REQUEST FOR COUNCIL ACTION

AGENDA SECTION: PUBLIC HEARINGS	ORIGINATING DEPT: PLANNING	ITEM NO. E-20
ITEM DESCRIPTION: Final Plat #03-02 by Roger Payne to be known as Century Hills Seventh Subdivision		PREPARED BY: Brent Svenby, Planner

CENTURY HILLS SEVENTH SUBDIVISION

RE: Final Plat #03-02 by Roger Payne to be known as Century Hills Seventh Subdivision. The Plat proposes to subdivide approximately 9.44 acres of land into 25 lots for single family development and proposes to dedicate right-of-way for a cul-de-sac roadway. The property is located south of 21st Street NE, east of Century Hills First Subdivision, west of Shannon Oaks Subdivision and north of Century Hills Sixth Subdivision.

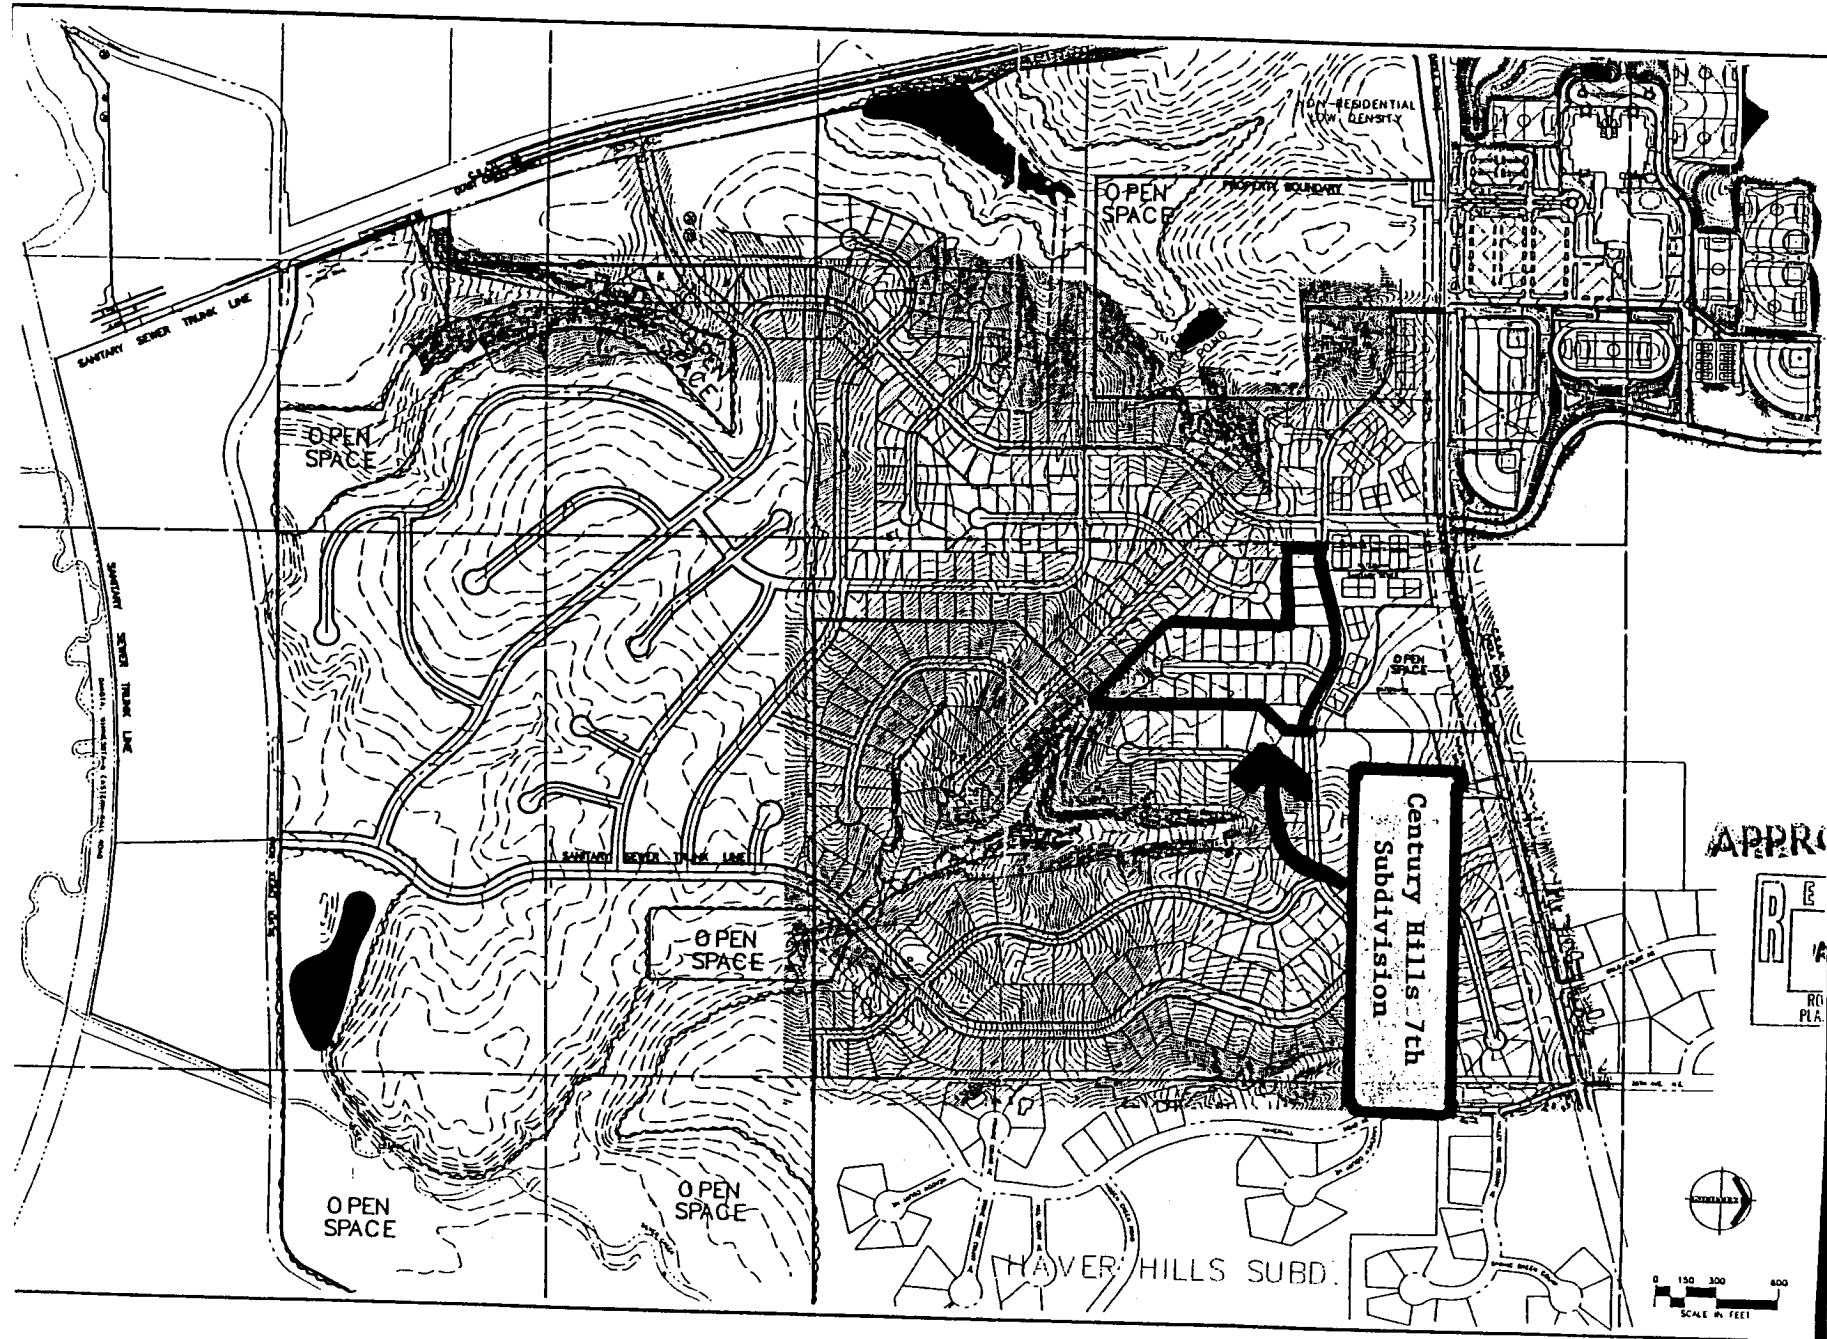
1. *Dedication of parkland shall be met via: Deferred land dedication, as recommended by the City Park & Recreation Department in the attached memo, dated February 27, 2003.*
2. *The cul-de-sac associated with this plan is indicated as less than 96 feet and shall be posted "No Parking".*
3. *Prior to recording the Final Plat for this development, the applicant shall dedicate an off-site drainage easement to point discharge stormwater between Lots 9 & 10.*

Grading and Drainage Plans have been approved. Stormwater runoff from the site is being conveyed to a temporary sedimentation basin to be constructed southeast of the plat. Dedication of an off-site drainage easement to point discharge stormwater between Lots 9 and 10 needs to be dedicated.

- 4. The cul-de-sac associated with this plan is indicated as less than 96 feet and shall be posted "No Parking" ~~along the entire length of the cul-de-sac.~~**

- 1. Dedication of parkland shall be met via: Deferred land dedication, as recommended by the City Park & Recreation Department in the attached memo, dated February 27, 2003.**
- 2. The cul-de-sac associated with this plan is indicated as less than 96 feet and shall be posted "No Parking".**
- 3. Prior to recording the Final Plat for this development, the applicant shall dedicate an off-site drainage easement to point discharge stormwater between Lots 9 & 10.**
